**SITE PLAN REVIEW SHEET
ENVIRONMENTAL VARIANCE REQUEST ONLY**

CASE: SP-2024-0147C.SH

PROJECT NAME: Loyola Flats

The applicant is requesting to vary from LDC 25-8-261(G) to allow floodplain modification in the Critical Water Quality Zone (CWQZ).

Floodplain Restoration/Mitigation Ratios ECM 1.7.5 & ECM 1.7.6

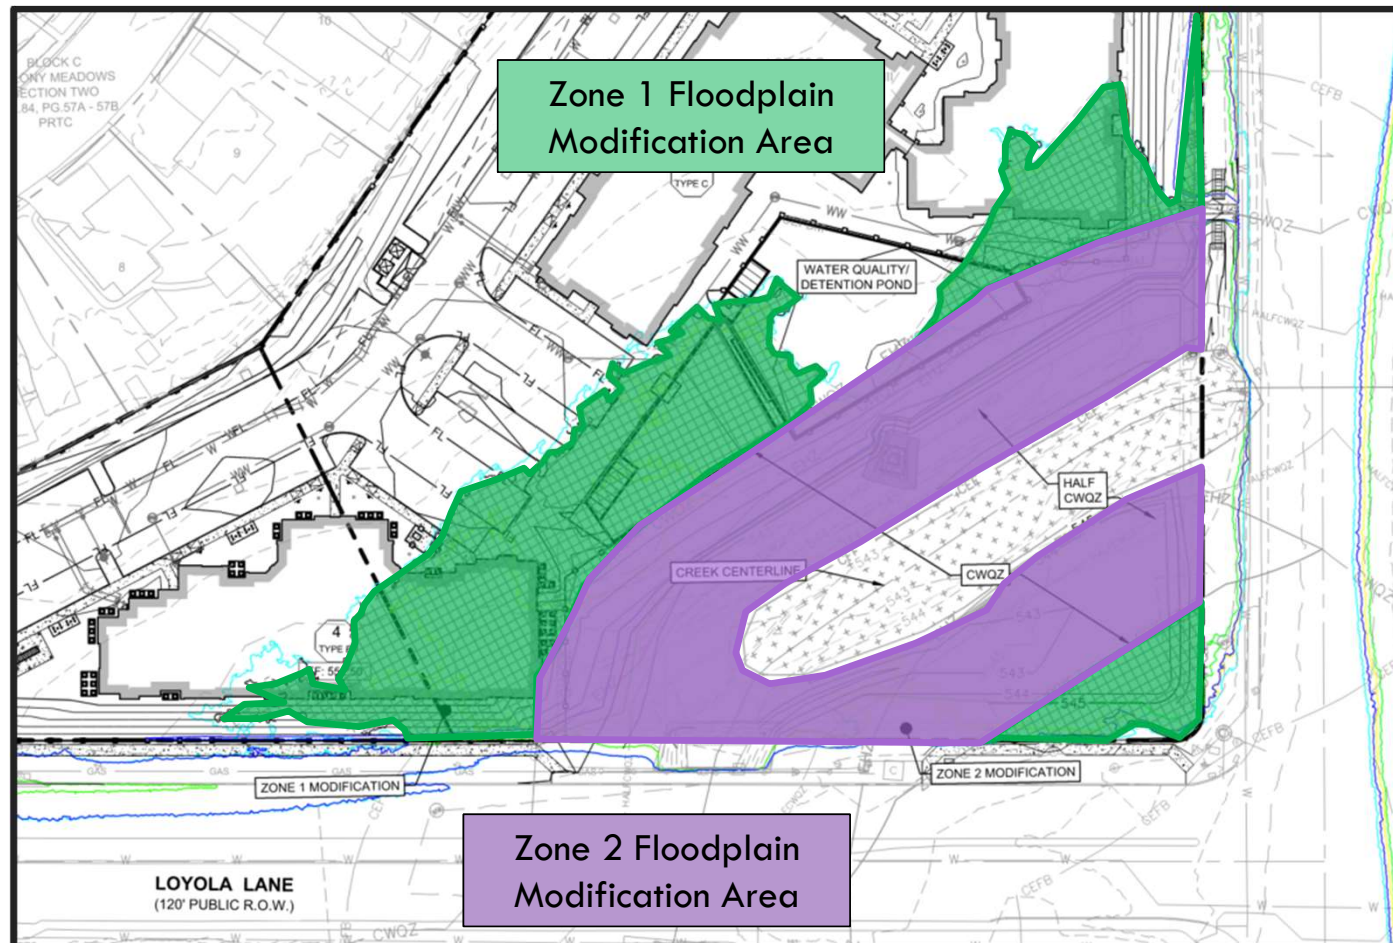
- Total Modification Area: 1.96 acres
- Zone 1 (Floodplain outside the CWQZ)
 - 0.84 acres
 - FAIR 3:1
 - 2.52 acres (Required Restoration/Mitigation)
- Zone 2 (Floodplain within the CWQZ)
 - 1.12 acres
 - FAIR 6:1
 - 6.72 acres (Required Restoration/Mitigation)
- **Total Required Restoration and/or Mitigation Area: 9.24 acres**

Floodplain Restoration/Mitigation Ratios ECM 1.7.5 & ECM 1.7.6

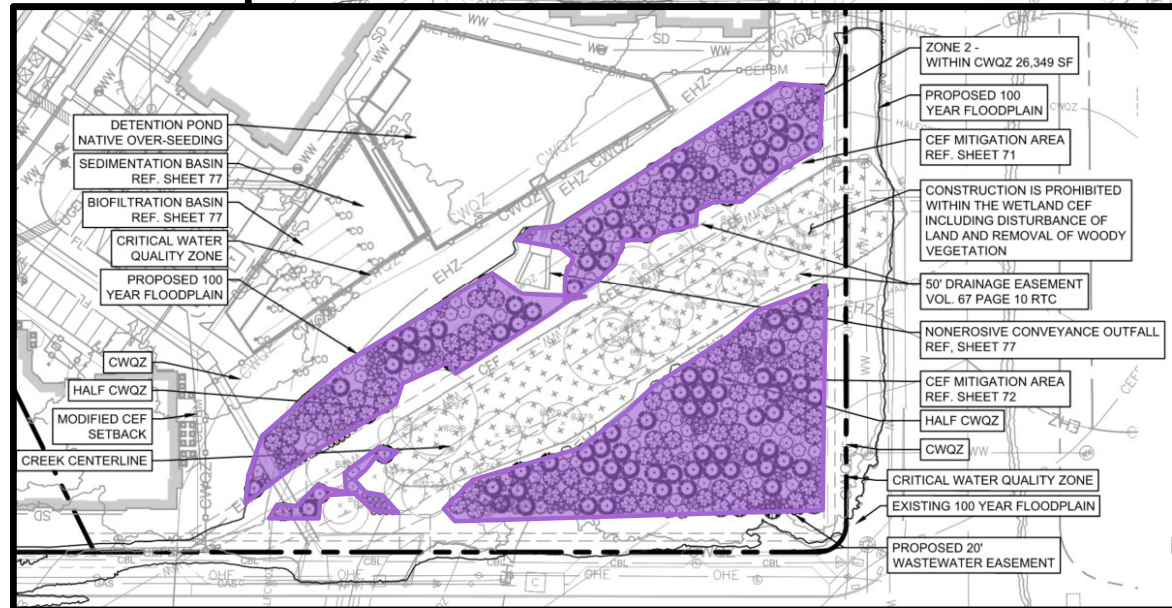
- Total Required Restoration and/or Mitigation Area:) **9.24 Acres**
- Zone 1 (Floodplain outside the CWQZ)
 - 2.52 acres
 - 0 acres (Restored)
 - 2.52 acres (Mitigated)
- **Zone 2 (Floodplain within the CWQZ)**
 - 6.72 acres
 - 0.61 acres (Restored)
 - 6.11 acres (Mitigated)
- **Total Restoration Area: 0.61 Acres**
- **Total Mitigation Area: 8.63 Acres**
 - \$382,157.63 Riparian Zone Mitigation Fund payment

Enhancements

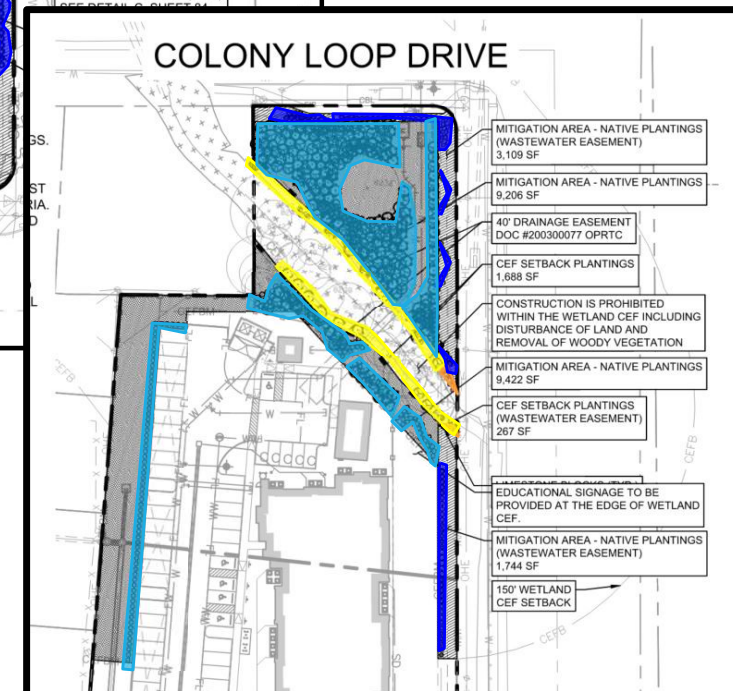
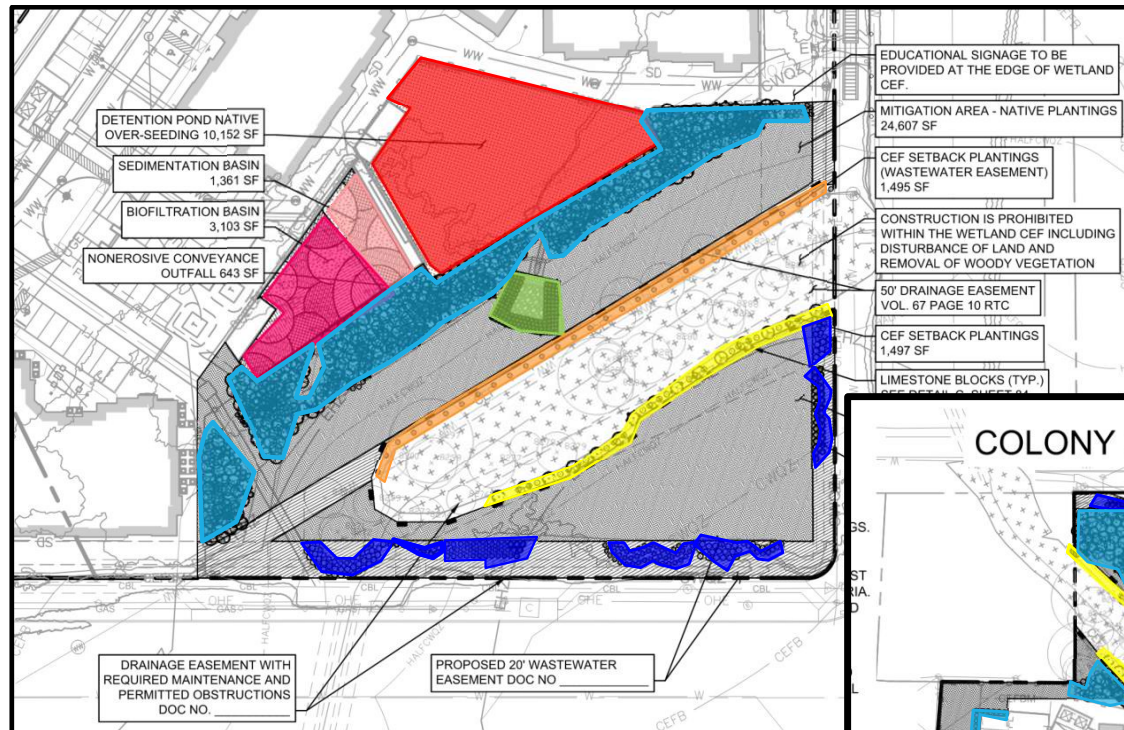
- ~44,000 sq ft of additional wetland mitigation
 - Native plantings in biofiltration pond
 - Native seeding in detention pond
 - Enhanced outfall
 - Native trees, shrubs, and bunchgrasses in CEF setbacks & mitigation areas
- Native pollinator species
 - Wetland CEF mitigation plantings
 - Floodplain restoration plantings

Enhancements:

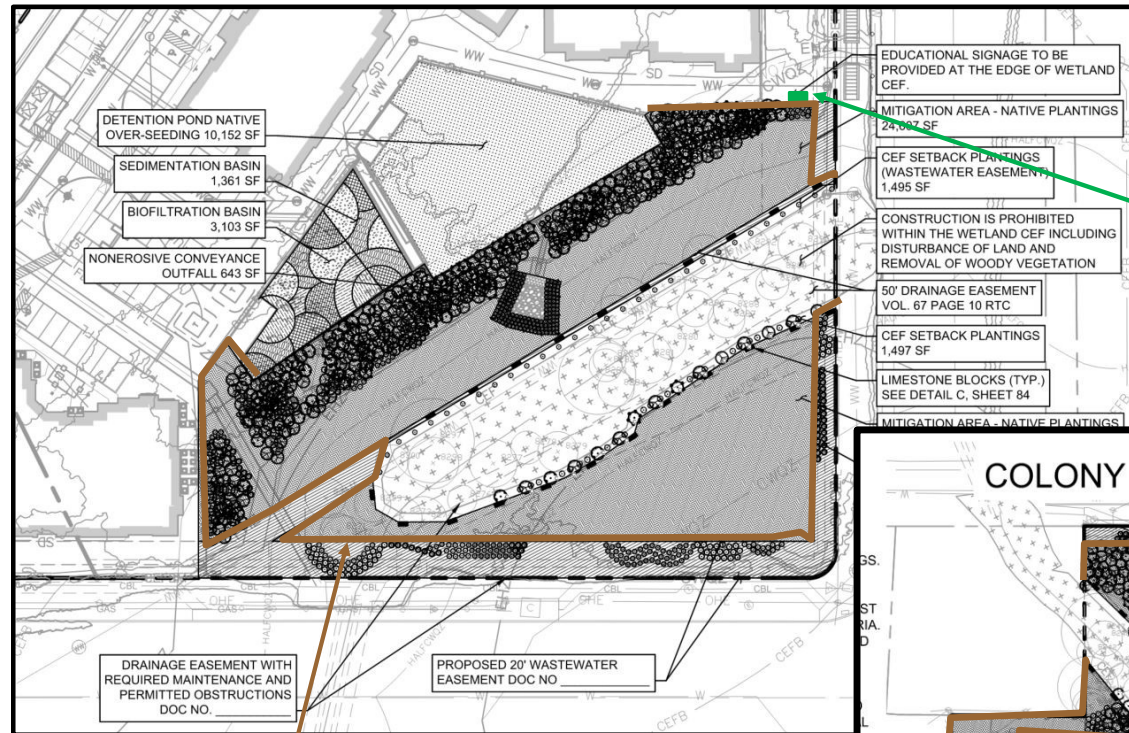
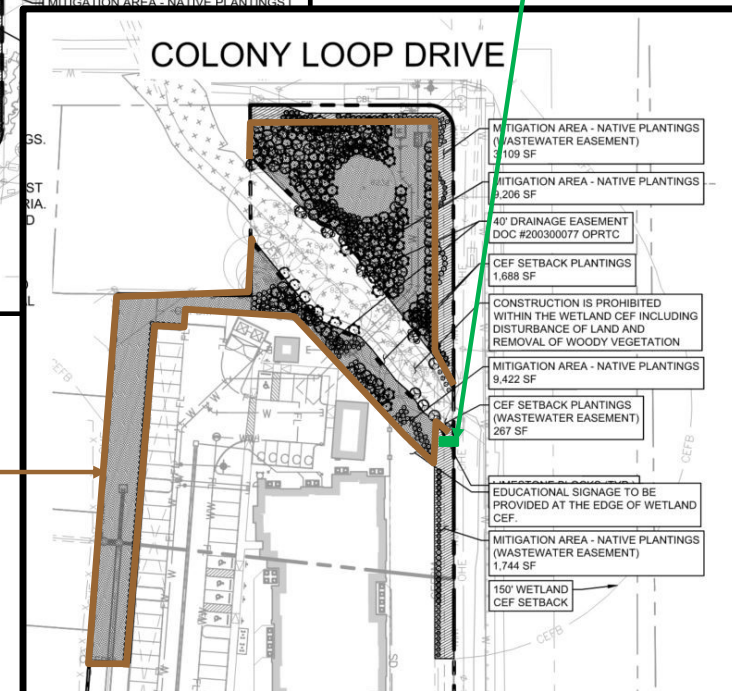
- Edge barrier of limestone blocks around perimeter of modified CEF setbacks/restoration areas
- Wetland CEF educational signage
